**Car Stereo  
Service Bulletin**

**Model:** XR-5500

**No. 282**

**Subject:** Description & Part Number Correction - Reference  
No. Q-623, Transistor, 2SA1150

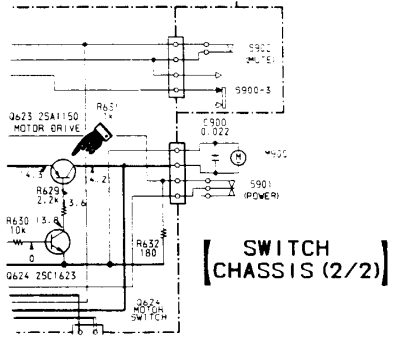
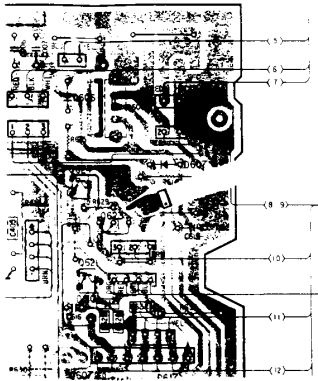
The description and part number listed on page 29 of the Service Manual for Ref. # Q-623, Transistor, 2SA1150, is incorrect.

Please note the correct description and part number as shown below.

REF	DESCRIPTION		PART NUMBER	
	INCORRECT	CORRECT	INCORRECT	CORRECT
Q-623	TRANSISTOR, 2SA1150	TRANSISTOR, 2SB772-Q	8-729-205-02	8-729-177-22
